INITIAL FIRE SAFETY INSPECTION REPORT

Tarasima Apparels Limited (Extension)

RSC ID: 25615

Date: 01 April, 2024

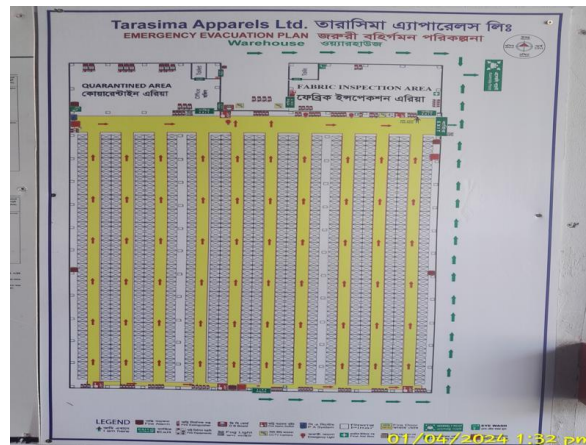
F-15	Means of Egress	The travel distance of the egress path at warehouse area from south to north exit exceeds 45 m.	<p>Reconfigure the egress arrangement so that the travel distance does not exceed 45 m (BNBC 2006 Part 4 Section 3.15.1). Travel distance shall be increased to 60 m (200 ft) where a complete automatic fire detection system portable fire extinguishers & standpipe system is provided and 122 m (400 ft) where a complete automatic sprinkler system is provided.</p> <p>Or, Provide required additional exits.</p>	Within 3 months
------	-----------------	---	---	-----------------
